**North Carolina Department of Transportation
PROJECT ENVIRONMENTAL CONSULTATION FORM
T.I.P. No. U-3330**

- A. Consultation Phase:** Right-of-Way
- B. Project Description:** US 301 Bypass Improvements
Rocky Mount, North Carolina, Nash County
- C. Federal Project No.:** STP-301 (28)
WBS No: 36596
- D. Document Type:** FONSI 1-8-2013
Date

III. CHANGES IN THE PROPOSED ACTION AND ENVIRONMENTAL CONSEQUENCES

Preferred Alternative
 Alternative A1
 Scale: 1" = 300'
 Exhibit 3.3a

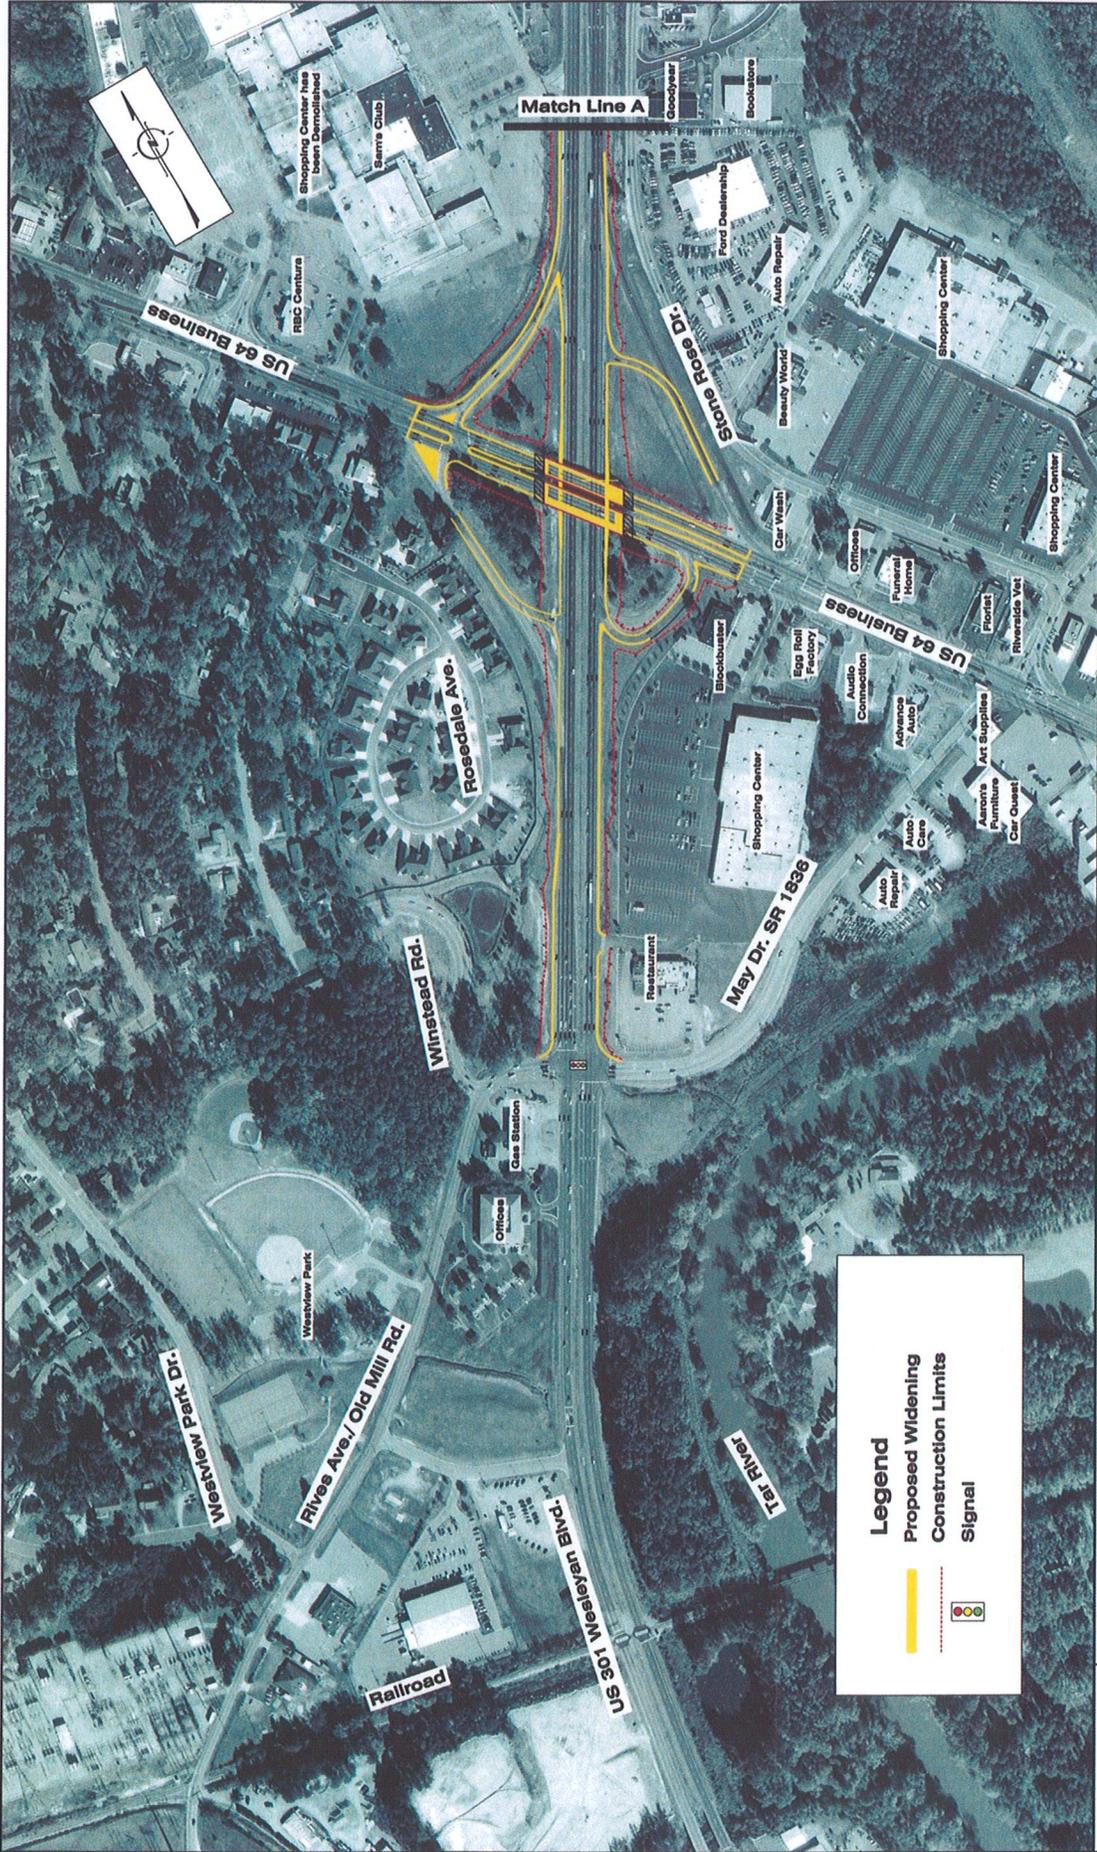
Exhibits 3.1a to 3.1c depict the preferred Alternative A1, which widens US 301 from four to six lanes, as presented as a new “hybrid alternative” in the FONSI.

1. The southern project terminus will be extended southward through the May Drive intersection, to incorporate repaving over existing pavement. This activity does not add any impervious area or create additional impacts.
2. During design phase, an unnamed tributary was newly-classified as a jurisdictional stream. See Exhibit 9.1: The stream is located on the west side of US 301, and south of Stoney Creek. To minimize impacts to this resource, NCDOT proposes to construct a retaining wall to limit fill from the US 301 widening.
